BID ADDENDUM NO.1

2181539 Bank on Buffalo, Niagara Falls, NY

There was an error during the printing process that caused the structural & HVAC items to not appear in the Architectural drawings. Some of the drawings being replaced are only to show the missing items for clarification. No actual changes are occurring on these sheets. Any changes to the drawings are clouded & tagged.

A501

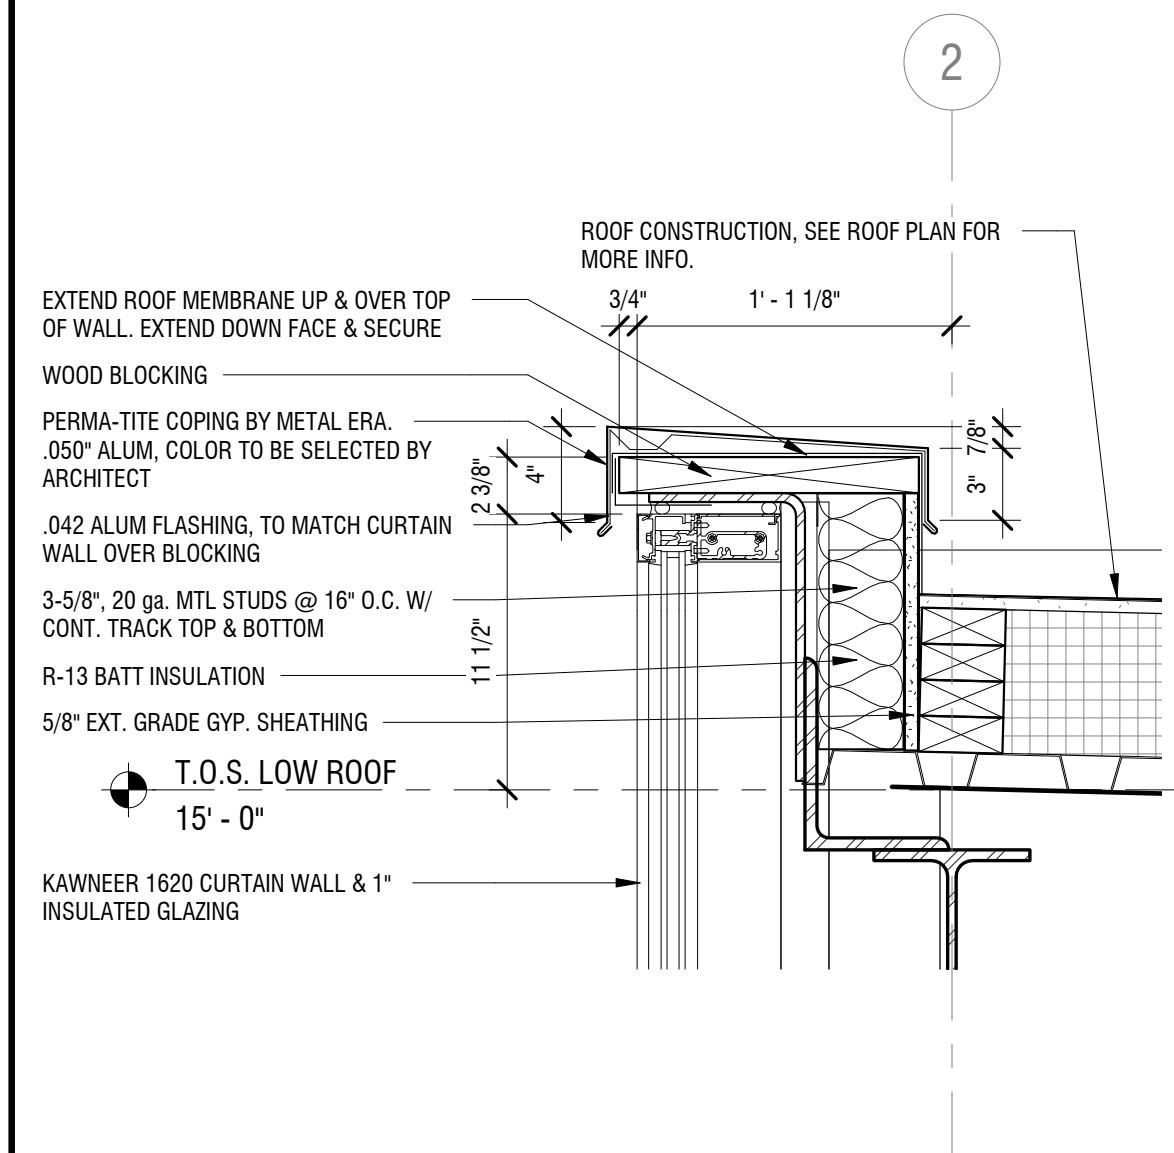
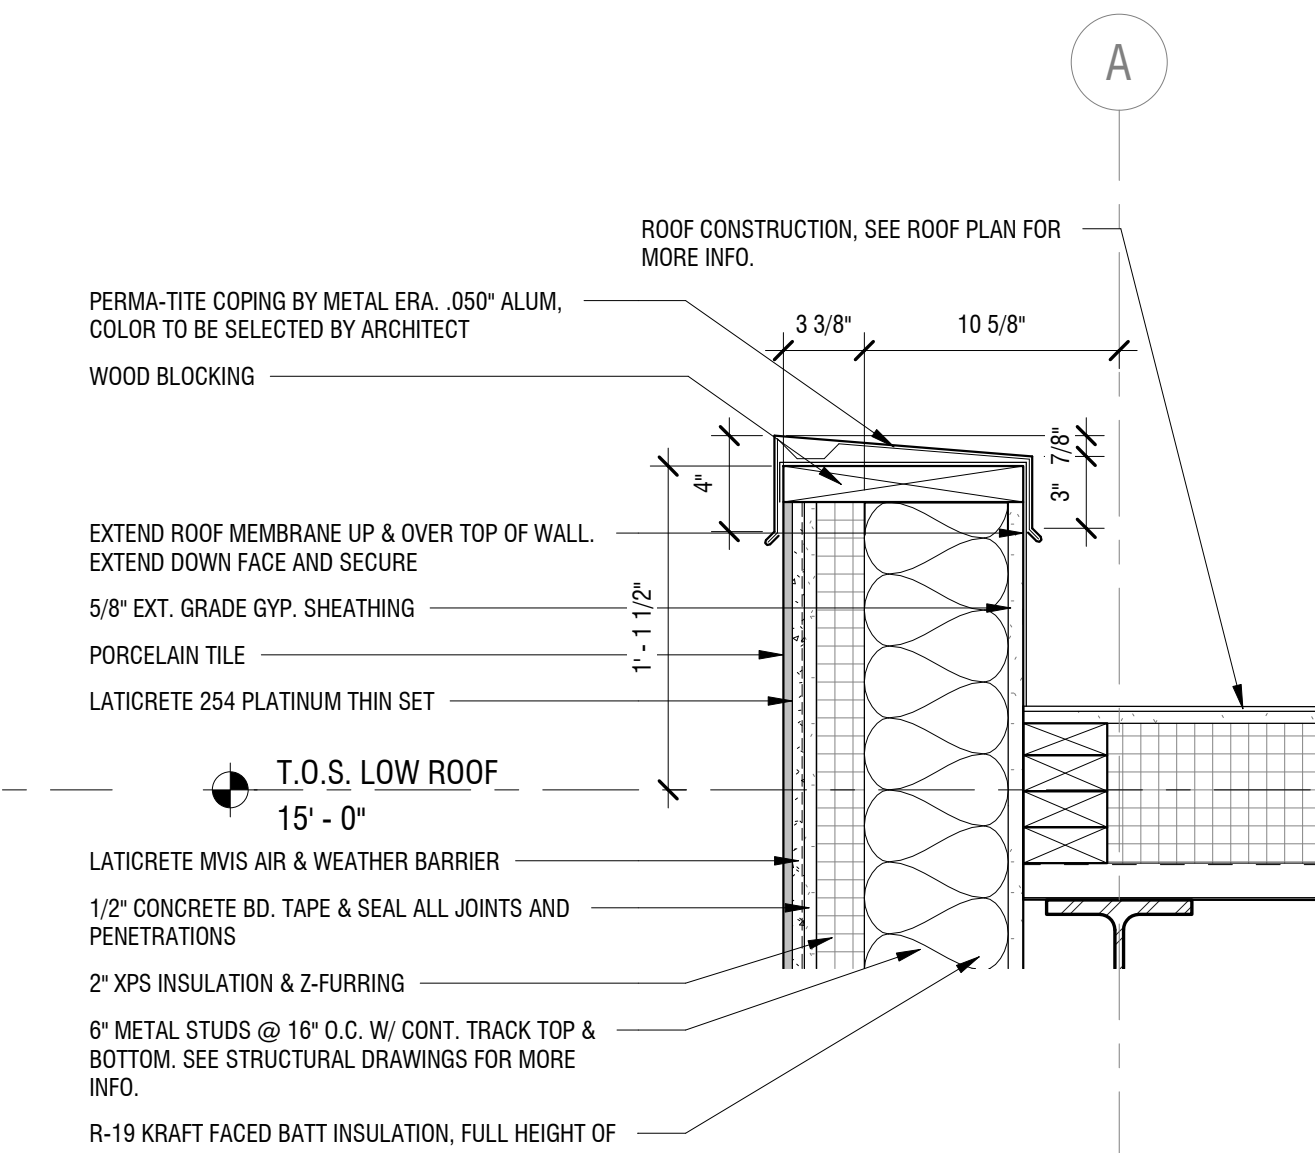
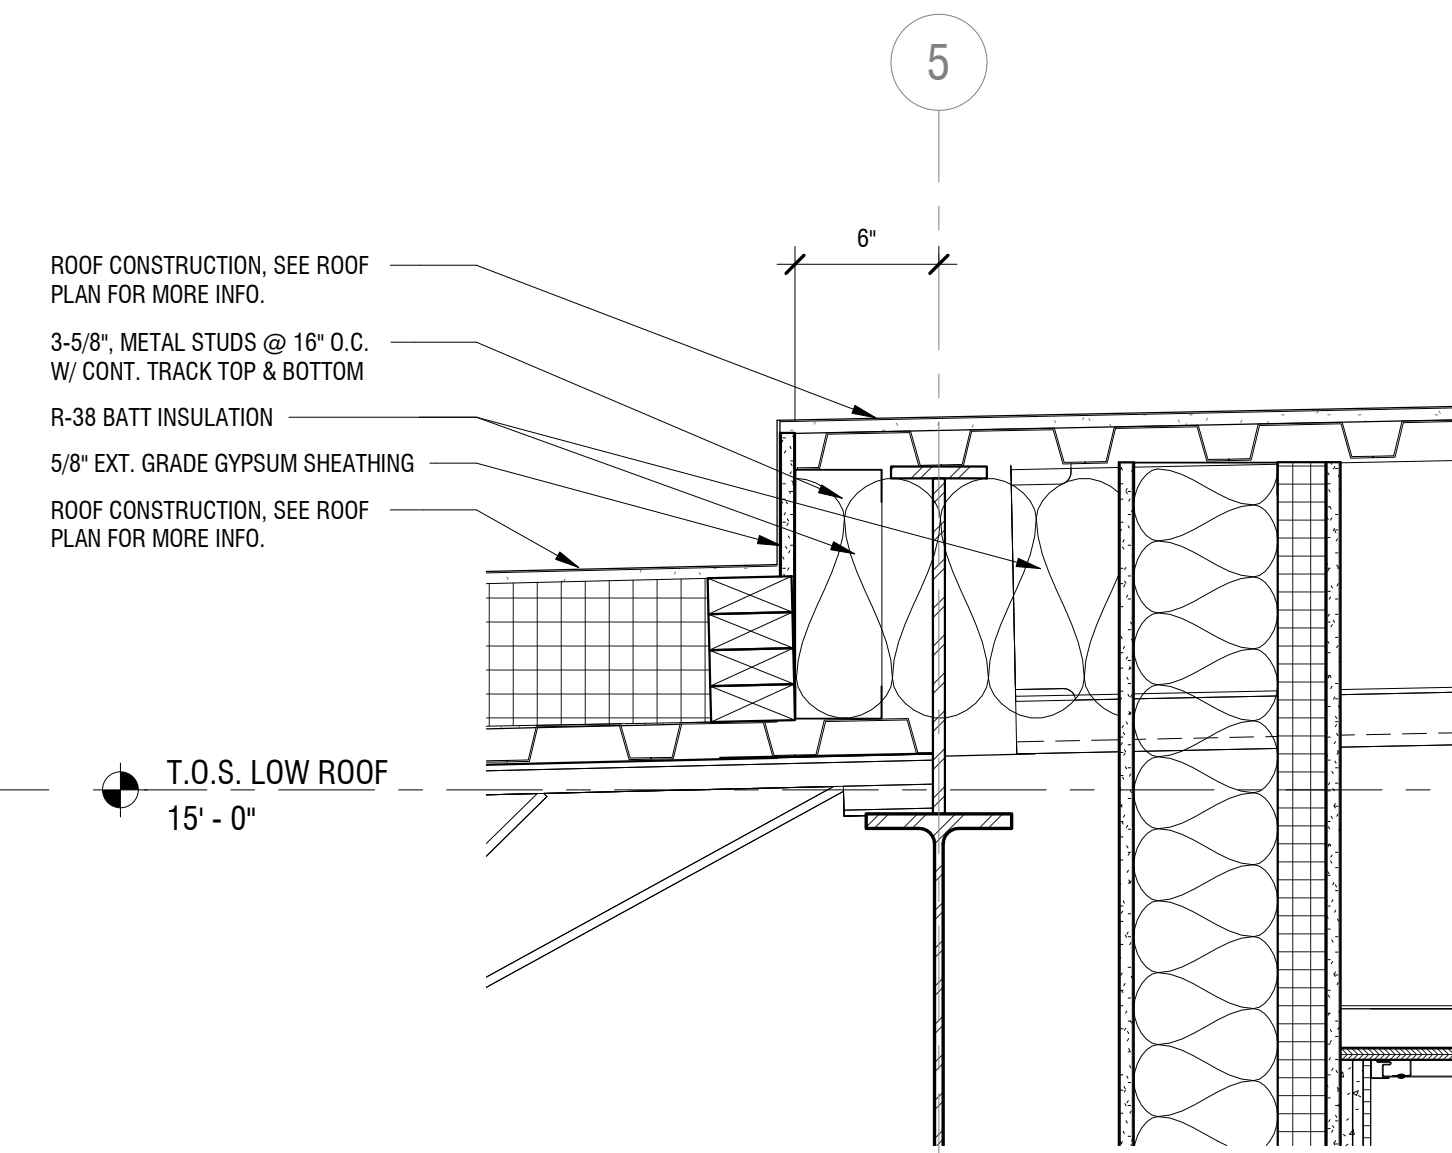
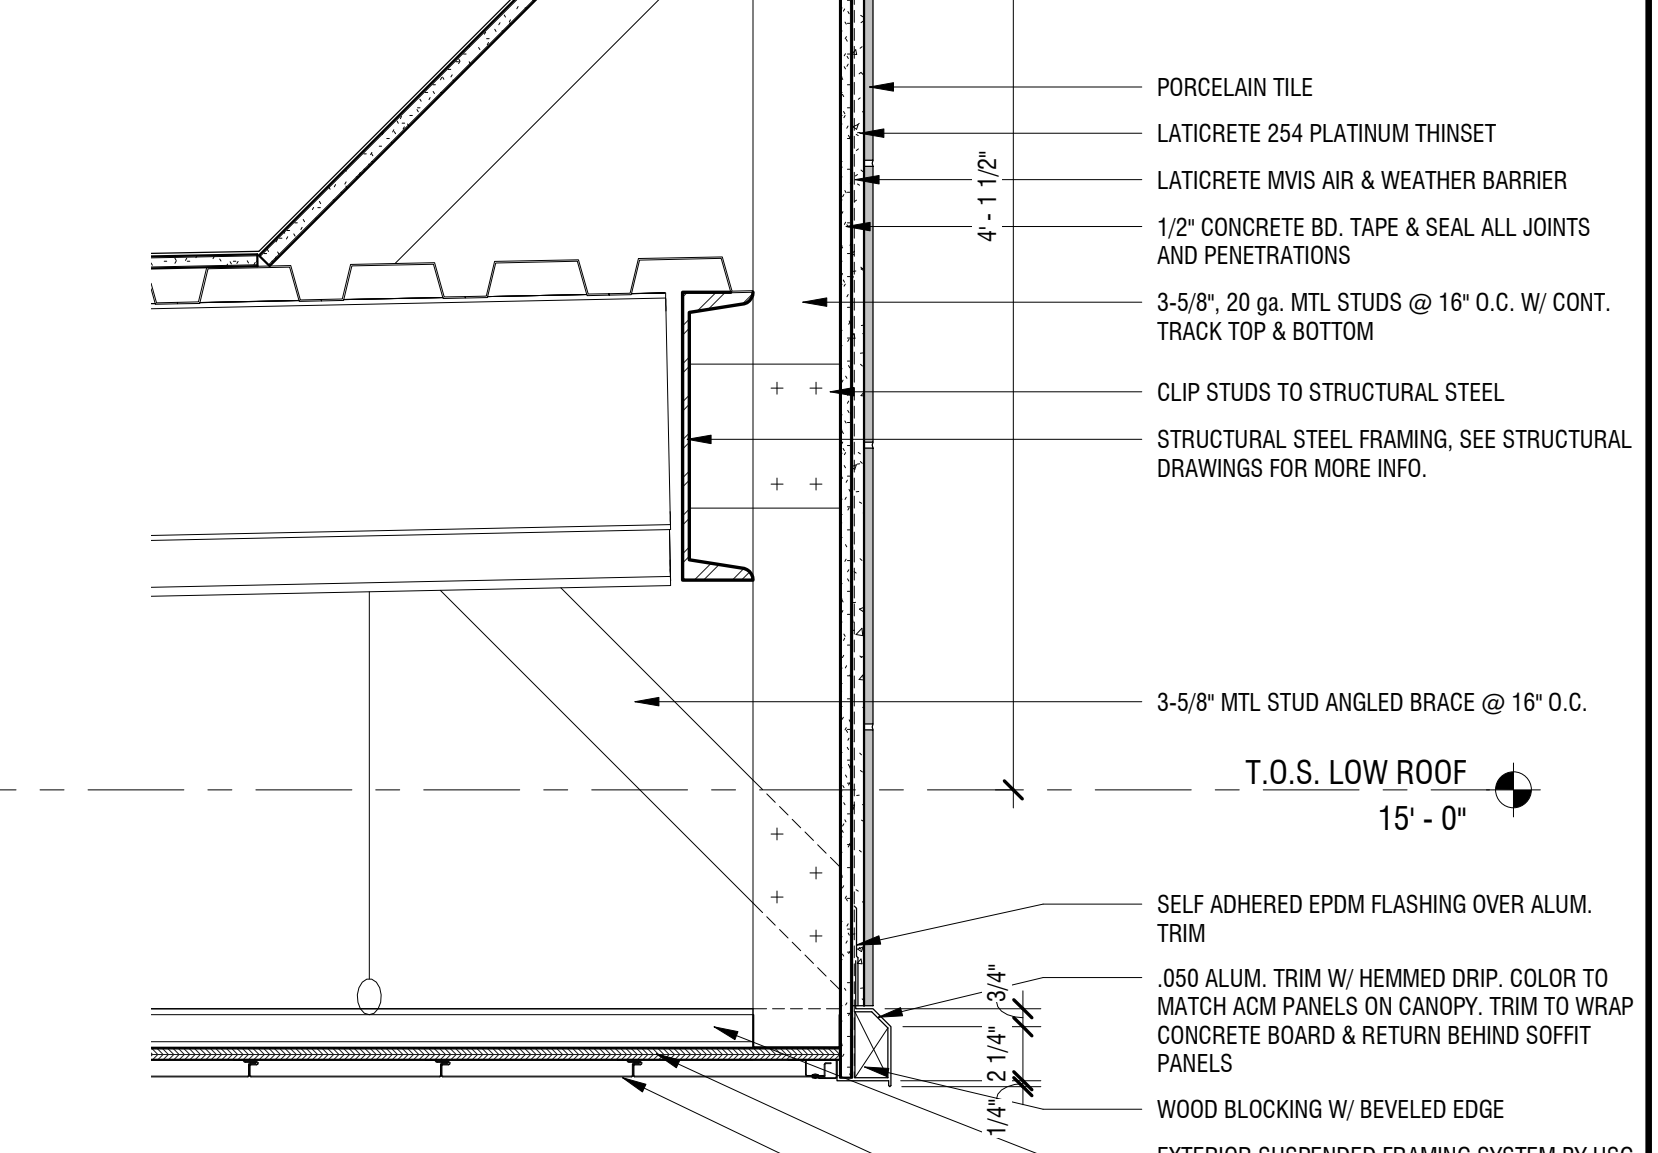
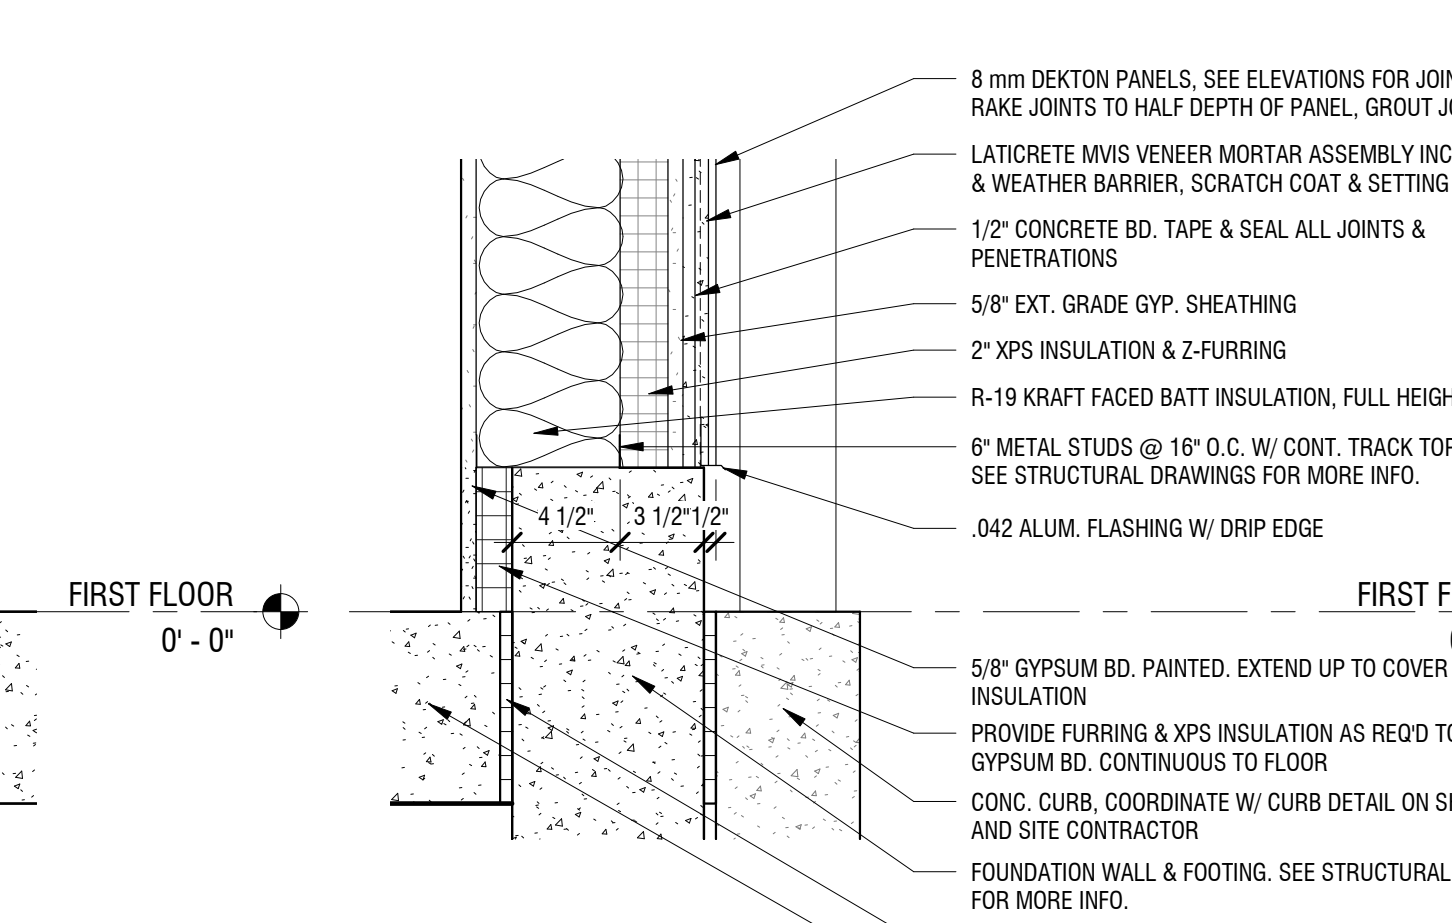
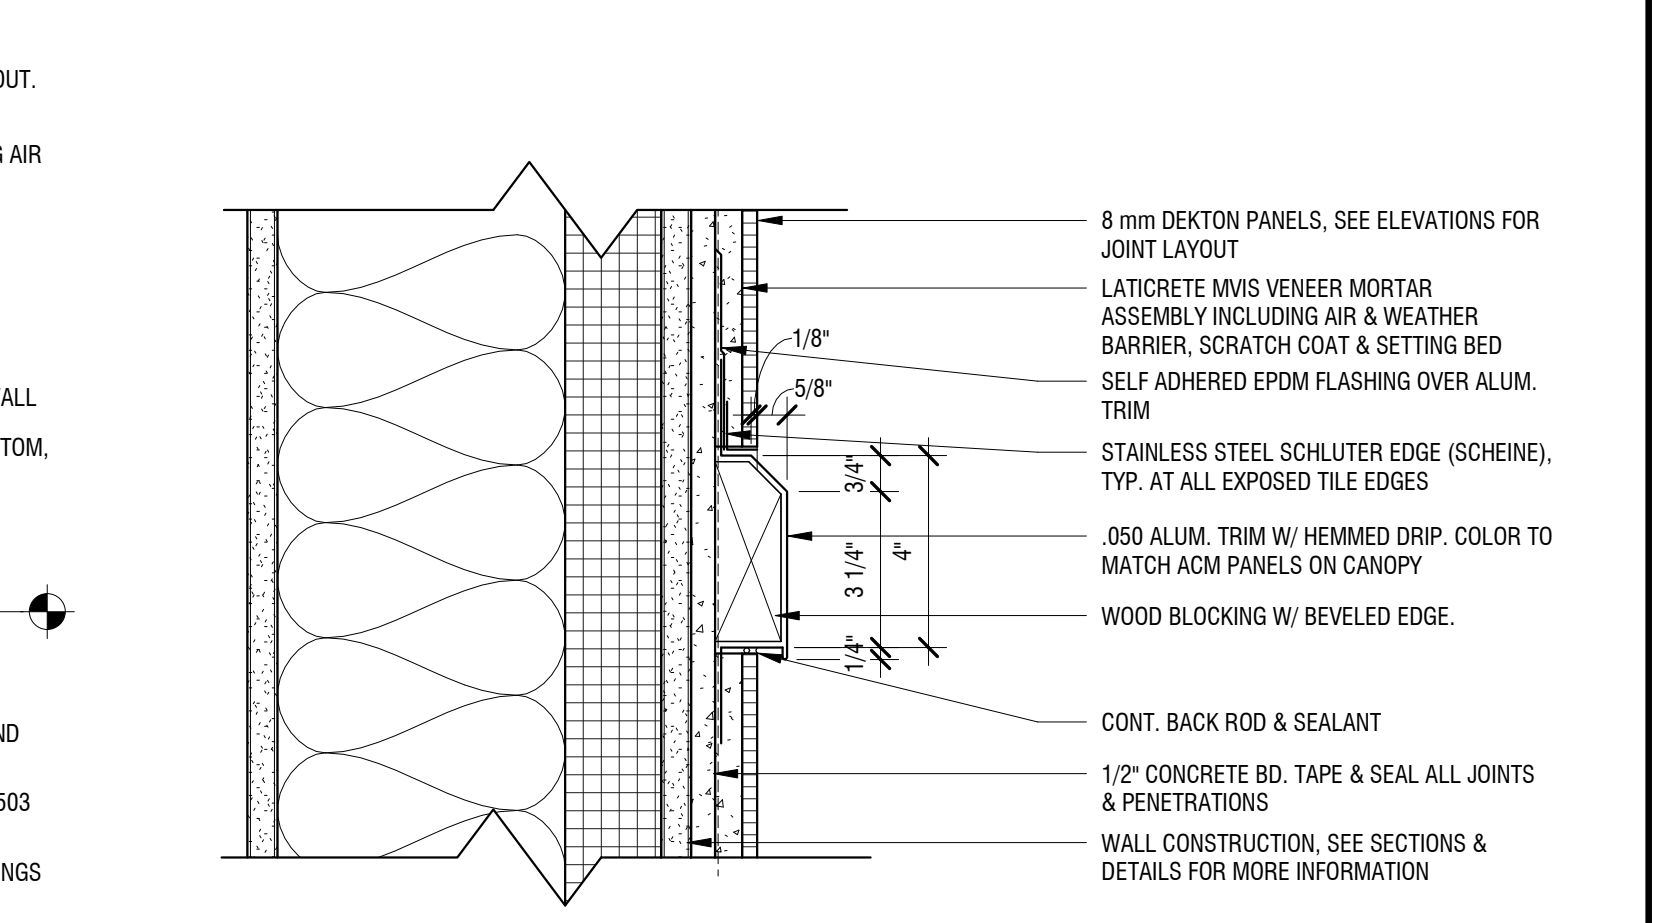
- M. Drawing A501**
 - 1. DELETE Drawing in its entirety
 - 2. ADD replacement Drawing A501
 - 3. Structural items are now shown on drawings.
